Department of Transportation and  
Public Facilities

RE: SFHWY 00171 HNS: MP12.2 to MP 23 Improvements / Proposed Waysides

**Table 1** Wayside Recommendations

HNS 17 14.5 MILE

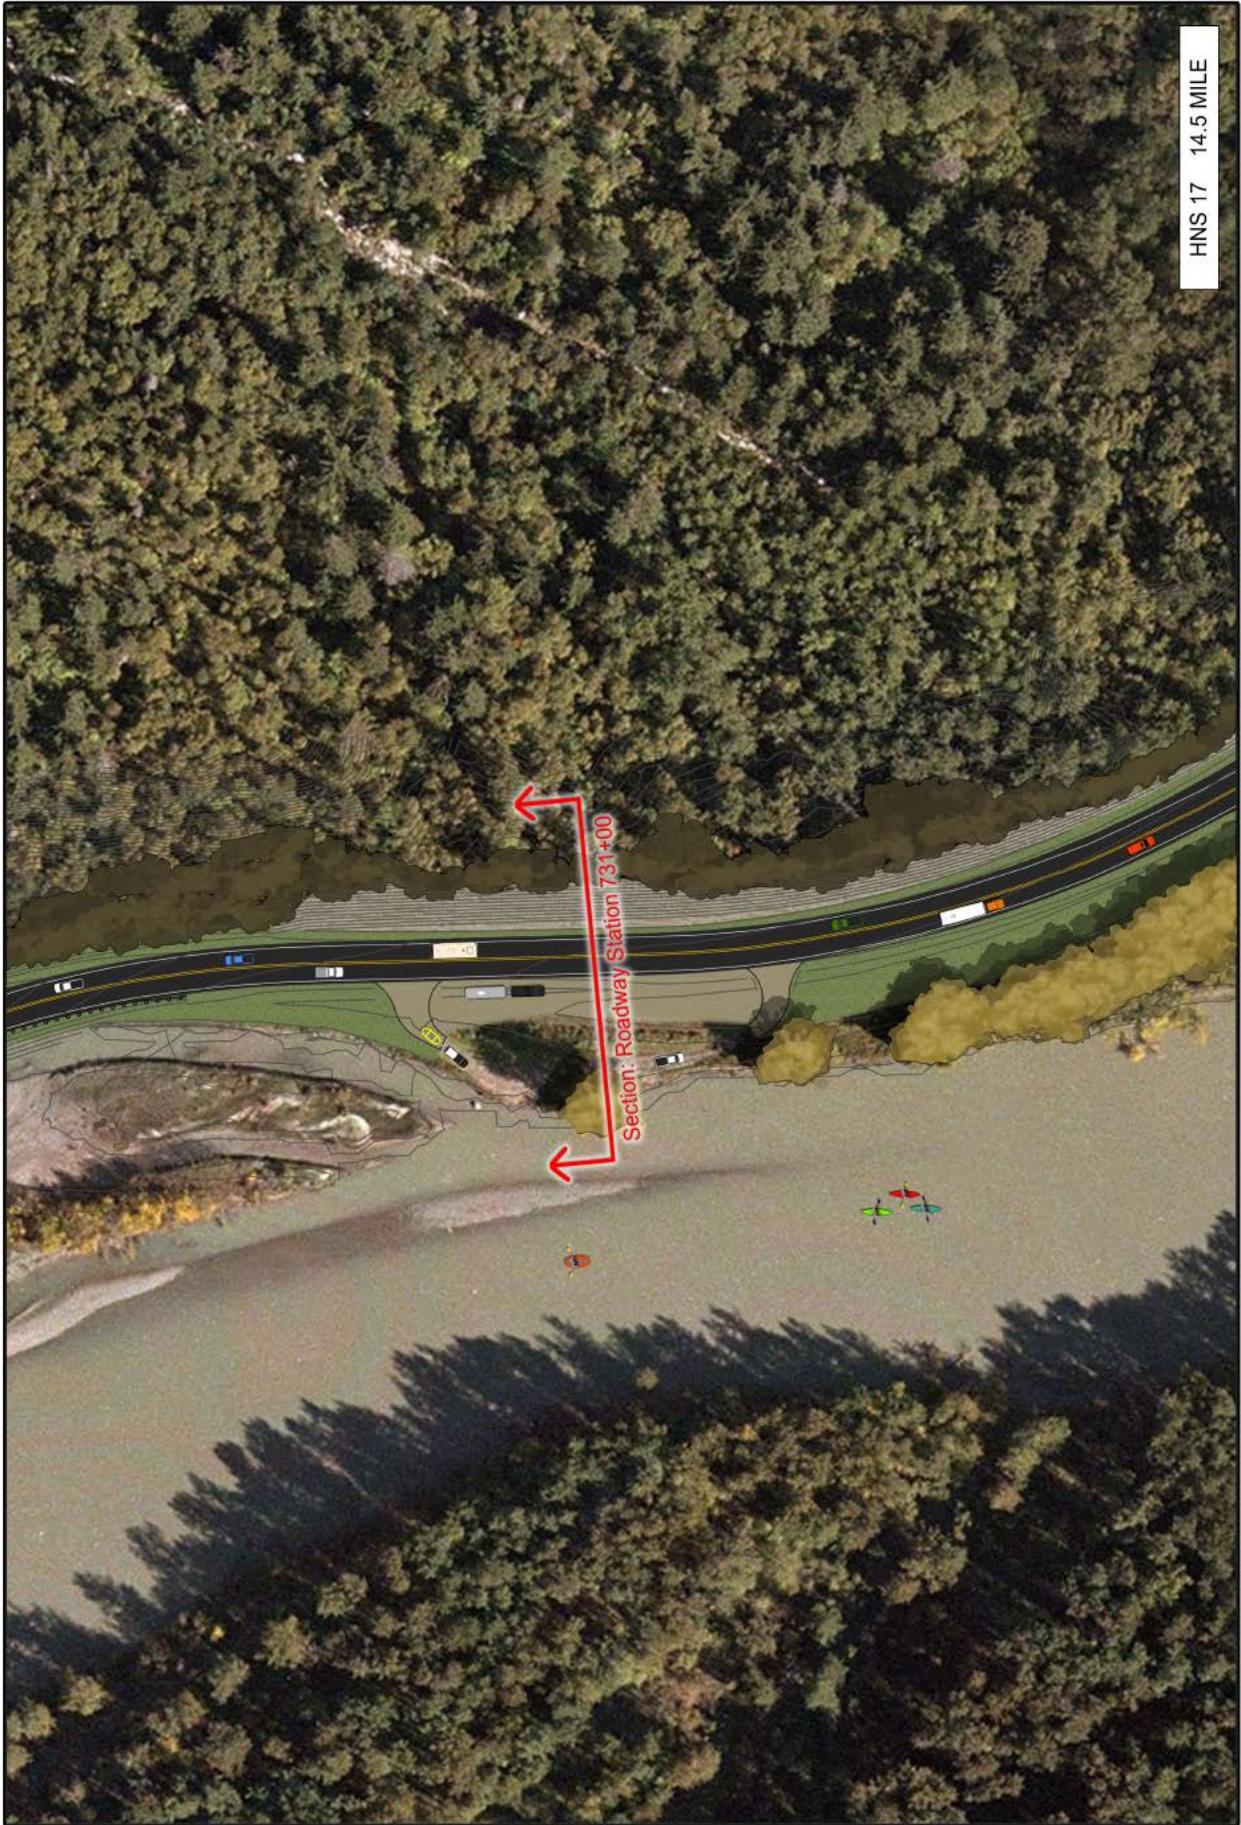
14.5 mile	HNS 17	<p>Current Recommendation. <i>DO NOT CHANGE THE GRADE OR DISTURB THE VEGETATED ISLAND. THE EXITS TO THE AREA NEED TO BE DESIGNED FOR BUS TRAFFIC. DNR WILL MAINTAIN.</i></p> <p>You may be referring/including this in the “currently revising proposed design – due to road alignment shifting landward and lowering, additional room and material will be available, please provide 2 appropriate 90 degree paved approaches and add parking and an outhouse (single?) in current vegetated island adjacent to current access road and create new vegetated “island” area in abandoned road location.</p>	Maintain access.	Maintain access. Provide a widened area where the existing roadway would be abandoned as shown on the attached graphic and sectional views. DOT&PF will not provide maintenance.
